Access Compliance Report

Public Rights-of-Way

(Curb Ramps)

Intersection ID: 27495	Main Street: BALLANTYNE_COMMONS_PY	Cross Street: NORTH_COMMUNITY_HOUSE_RD	Location: SE
ADA ID: ADD1A4D05BA0	Ramp Type: Perp	Initial Pass/Fail: Fail	Overall Compliance: No
Severity Score: 8.75			
Codes/Mitigation Info/Possible Solution		Field Measurements/Component Compliance

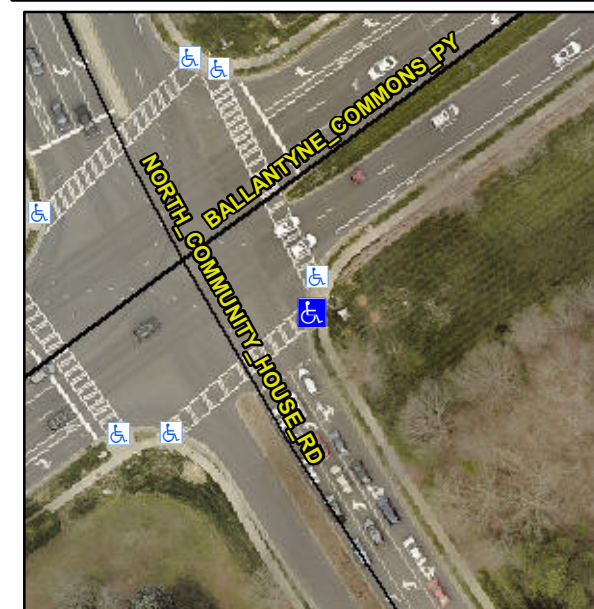
Not Found, R304.5.1

Compliance	Description	Data	Compliance	Description	Data
N/A	Ramp Length (in)	107.0	Yes	Ramp Slope (%)	6.0
No	Ramp Width (in)	38.0	Yes	Ramp XSlope (%)	0.4
N/A	Flare Type LT	N/A	N/A	Flare Type RT	N/A
N/A	Flare Slope LT (%)	N/A	N/A	Flare Slope RT (%)	N/A
N/A	Flare Traversable LT?	N/A	N/A	Flare Traversable RT?	N/A
N/A	Landing Length (in)	N/A	N/A	DWS Provided?	N/A
N/A	Landing Width (in)	N/A	N/A	DWS Contrast?	N/A
N/A	Landing Slope (%)	N/A	N/A	DWS Length (in)	N/A
N/A	Landing X Slope (%)	N/A	N/A	DWS Full Width?	N/A
N/A	Landing Curb? (Y/N)	N/A	N/A	DWS Offset (in)	N/A
N/A	Shared Landing?	N/A			
N/A	Gutter Ponding?	N/A	N/A	Gutter Slope (%)	N/A
N/A	Gutter Lip Ht (in)	N/A	N/A	Gutter X Slope (%)	N/A
N/A	Painted X Walk1?	Yes	N/A	Painted X Walk2?	N/A
	X Walk 1 Direction	To SW		X Walk 2 Direction	N/A
N/A	X Walk 1 Width (in)	124.0	N/A	X Walk 2 Width (in)	N/A
	X Walk 1 Slope (%)	2.2		X Walk 2 Slope (%)	N/A
	X Walk 1 X Slope (%)	2.9		X Walk 2 X Slope (%)	N/A

Remove & Replace Entire Ramp.
